<b>ITEM: 6.12</b>	<b>REPORT SUMMARY MINOR VARIANCE APPLICATION FILE NUMBER A062/24</b>
-------------------	--

**MINOR VARIANCE APPLICATION  
FILE NUMBER A062/24  
142 FIFTH AVENUE, WOODBRIDGE**

<b>CITY WARD #:</b>	3
<b>APPLICANT:</b>	Ali Sirzad Bagheri Sadr
<b>AGENT:</b>	Mehran Heydari & Winnie Ko
<b>PROPERTY:</b>	142 Fifth Avenue, Woodbridge
<b>ZONING DESIGNATION:</b>	See below.
<b>VAUGHAN OFFICIAL PLAN (2010) DESIGNATION:</b>	Vaughan Official Plan 2010 ('VOP 2010'): "Low-Rise Residential"
<b>RELATED DEVELOPMENT APPLICATIONS:</b>	None
<b>PURPOSE OF APPLICATION:</b>	Relief from the Zoning By-law is being requested to permit a proposed cabana located in the rear yard and a utility room located in the side yard (south). Relief is also being requested to permit reduced landscaping requirements in the rear yard.

**SITE PLAN**

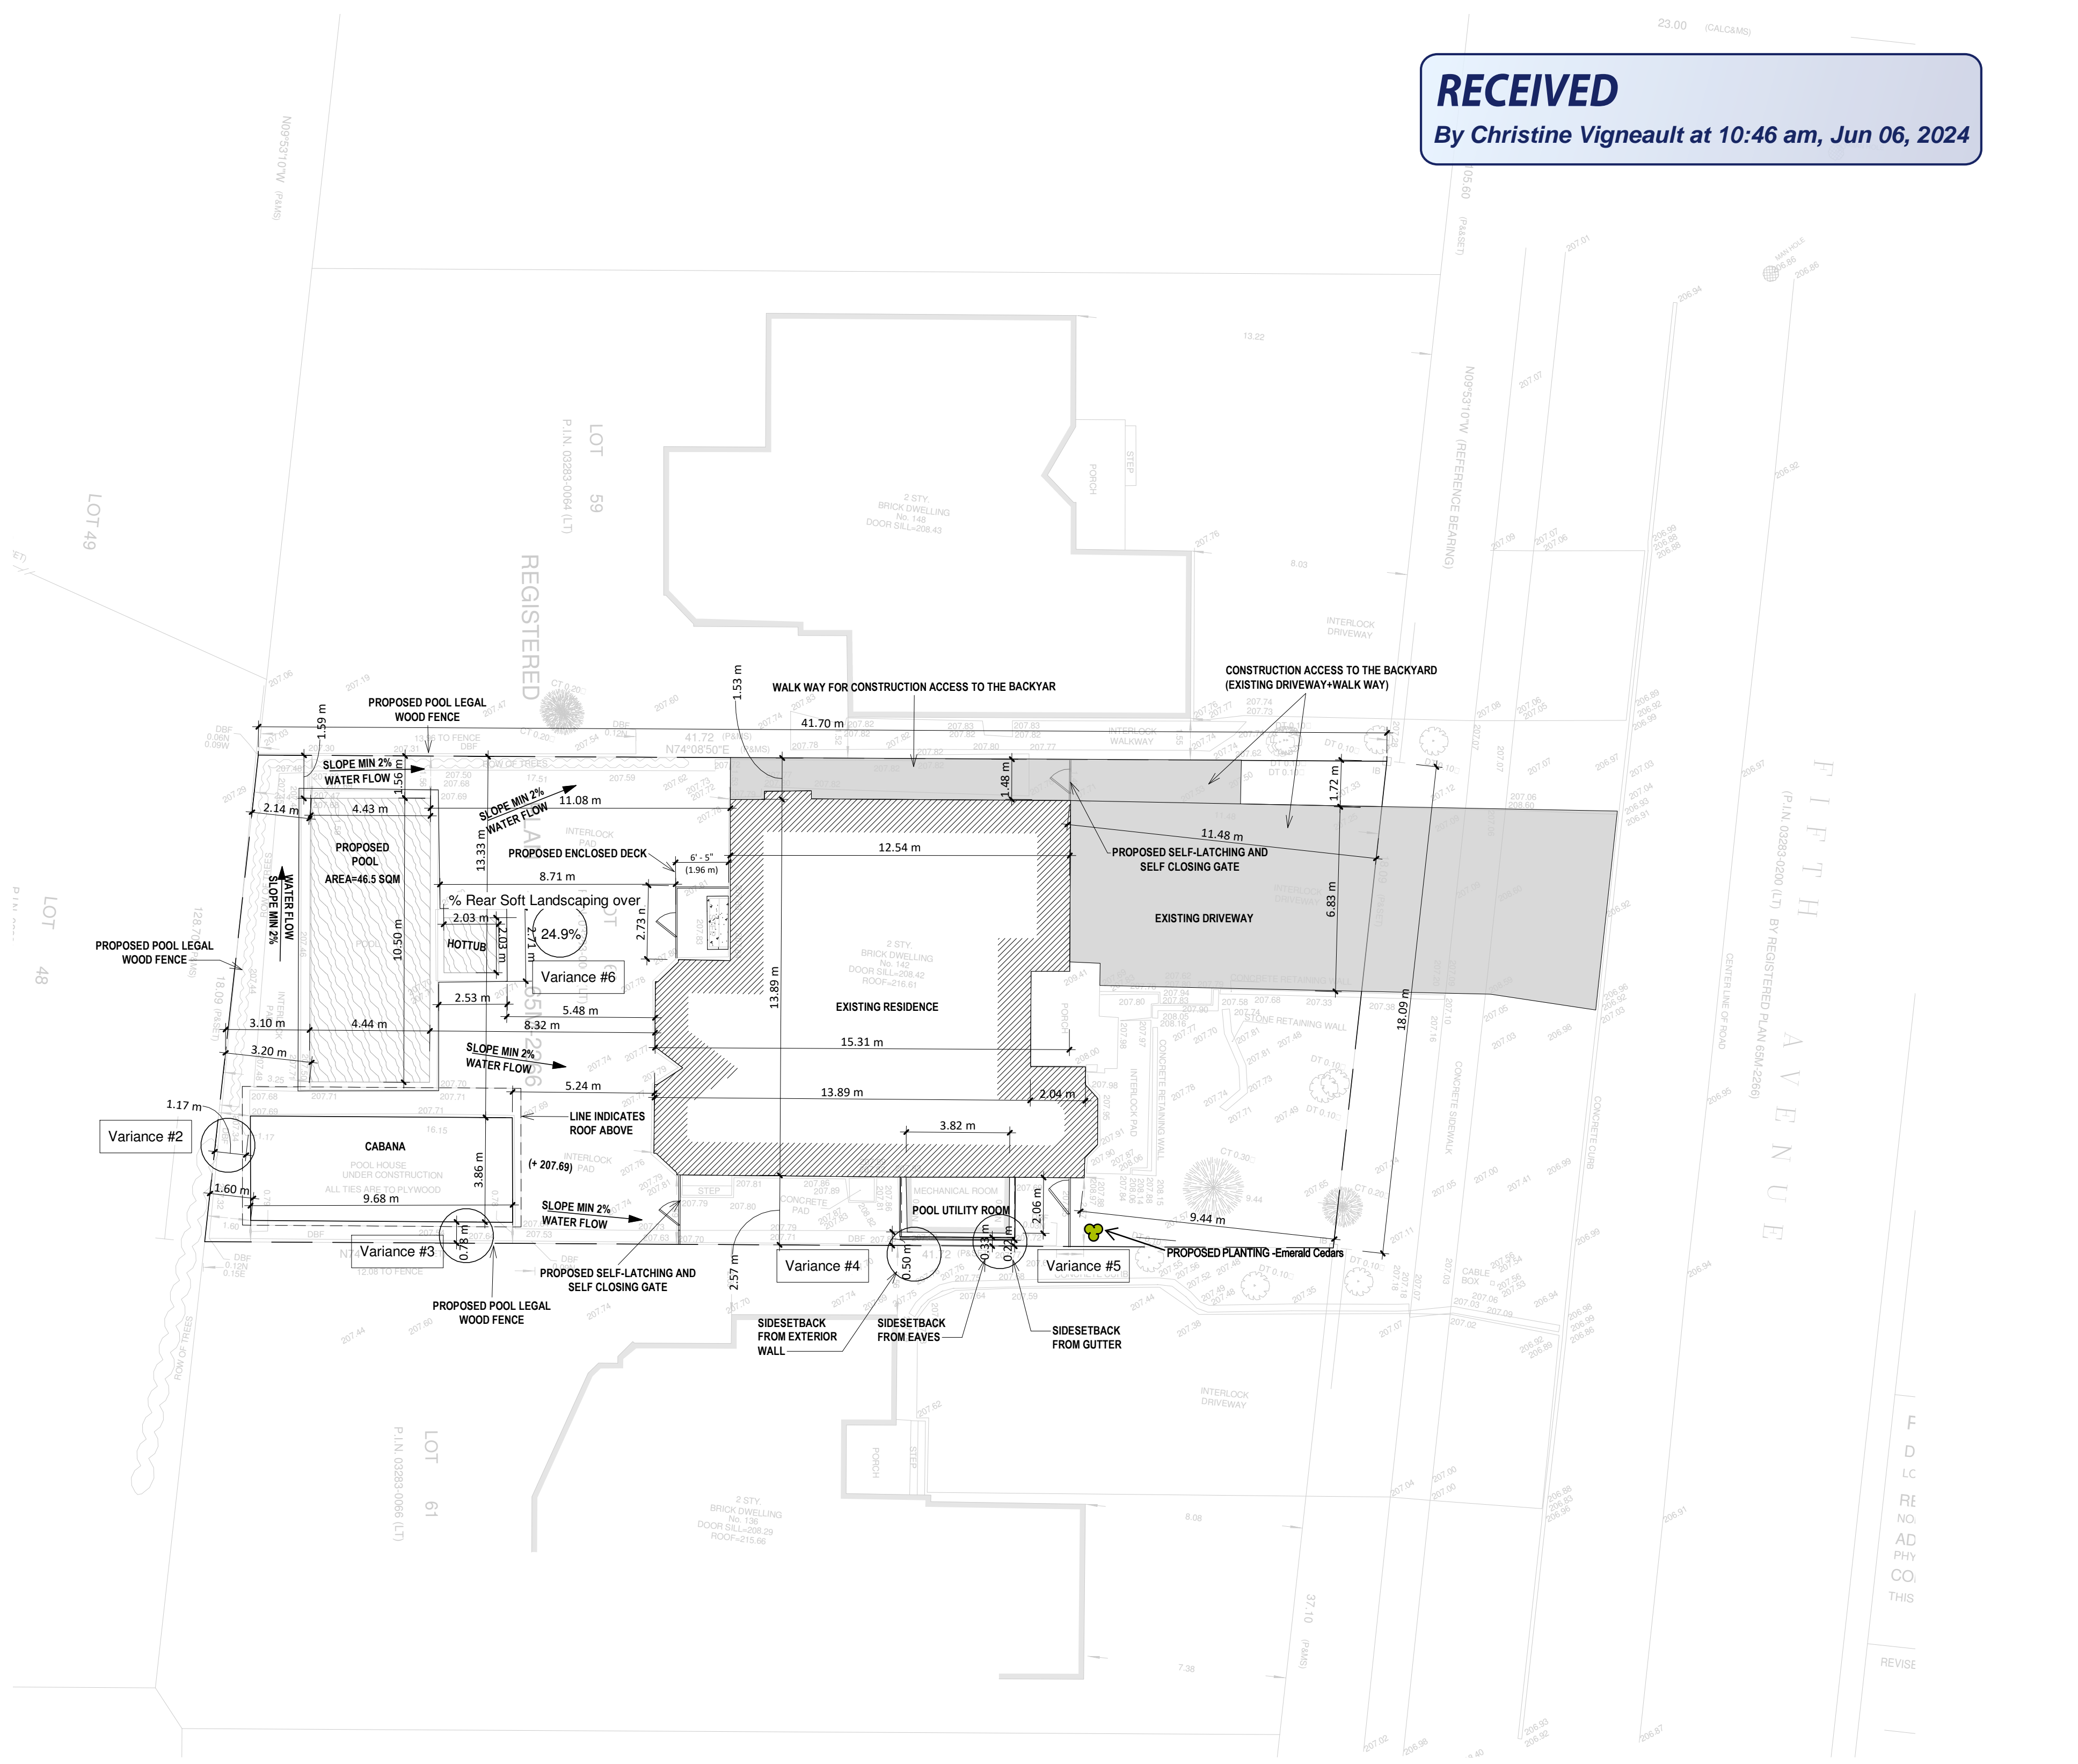
Development Planning Staff have no objections for the proposed reduction in soft landscaping in the rear yard (Variance 6). The soft landscaping around the rear yard's perimeter (42.35 m<sup>2</sup>) is sufficiently sized to contain the many cedar trees which have been planted along the northern interior side lot line and the rear lot line. River rock runs along the southern interior side lot line and behind the portion of the Cabana facing the rear lot line. Development Planning Staff are satisfied with number of plantings along the entire north side lot line and the majority of the rear lot line which helps provide a natural buffer between the existing swimming pool and Cabana and the abutting properties. The scale of cedar tree vegetation proposed within most of the softscape areas also helps create a balance between it and the existing hardscape in the rear yard. Staff also appreciate that once the cedar plantings mature, the vegetative buffer between the subject rear yard and neighbouring rear yards will be further enhanced. Development Engineering Staff have also reviewed the application and do not have any concerns regarding drainage in the rear yard. As such, Development Planning Staff are of the opinion that the proposed reduction in rear yard soft landscaping is desirable and appropriate for the development of the land and does not adversely impact the surrounding neighbours or character of the existing neighbourhood.

**FLOOR PLAN  
 (UTILITY ROOM)**

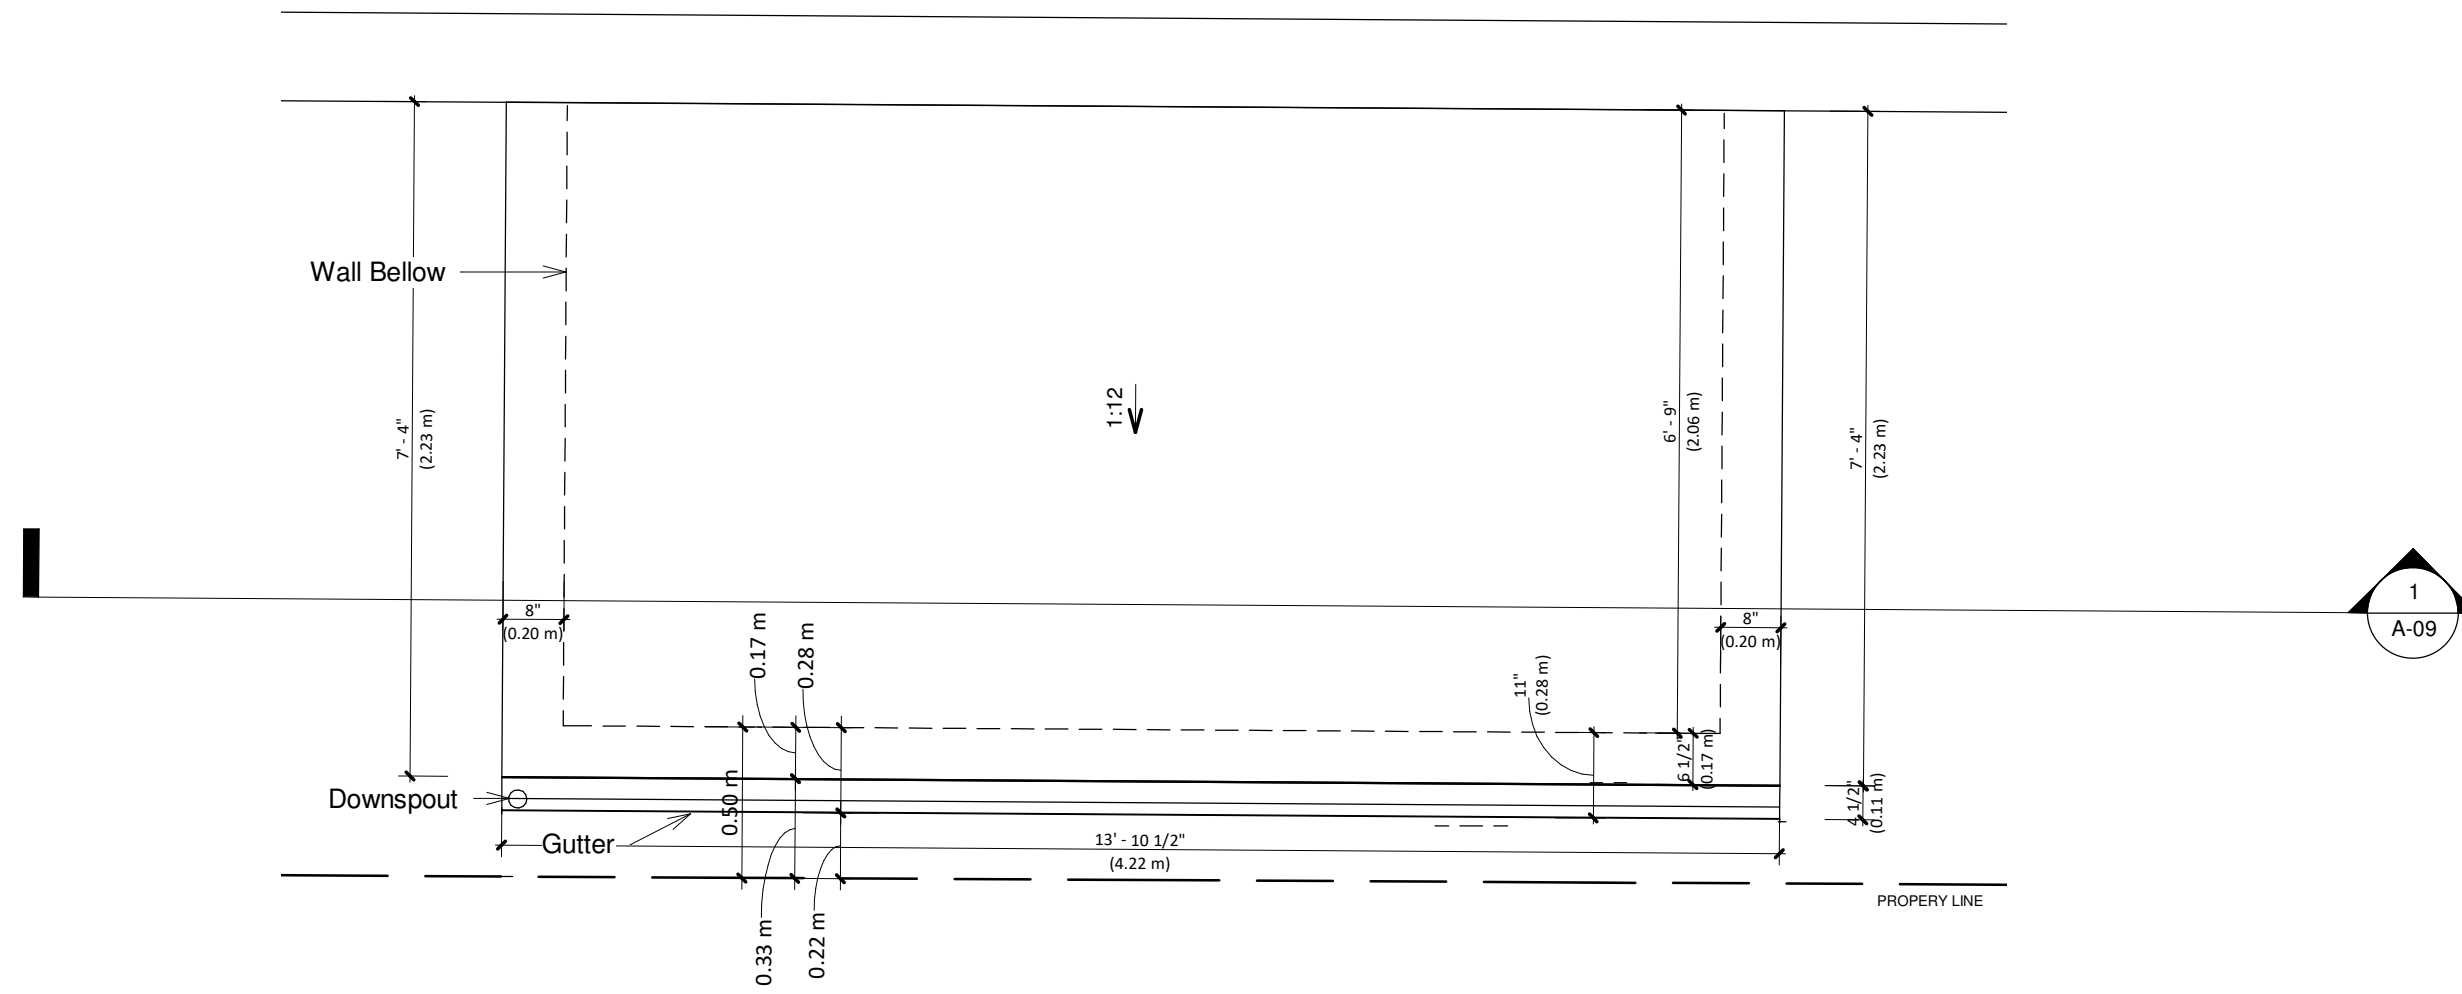
Development Planning Staff have no objection to Variances 4 and 5 to permit a reduced interior side yard setback measured to the eaves (Variance 5) and to the wall of the Utility Room (Variance 4). While attached to the dwelling, the Utility Room appears and functions as an accessory structure. The Utility Room is utilized to house pool equipment for the existing in-ground pool and will have doors on its east and west walls to provide access between the front and rear yards on the south side of the dwelling.

The existing Utility Room is located in the interior side yard and spans under one-third of the dwelling's south wall close to the existing gate entrance to the rear yard and is therefore visible from the street (Fifth Avenue). There are two (2) existing mature emerald cedar trees present on the neighbouring property (136 Fifth Avenue) abutting the privacy fence where the Utility Room is situated, thus helping provide screening to the south. Additionally, at the request of Development Planning Staff, the Owner agreed to install emerald cedar planting(s) on the east side of the Utility Room to provide additional screening in relation to the existing streetscape on Fifth Avenue. The Utility Room's proposed 0.50 metre setback provides sufficient space for maintenance purposes and there is no eave overhang onto the neighbouring property (136 Fifth Avenue). The height and footprint of the single storey Utility Room are relatively modest, and it abuts a very small portion of the dwelling's two storey wall which it is attached to. As such, the Utility Room's scale (mass) in conjunction with the existing and proposed vegetative buffering is not anticipated to have adverse use or massing impacts on the neighbouring property to the south (136 Fifth Avenue) or the existing streetscape and neighbourhood.
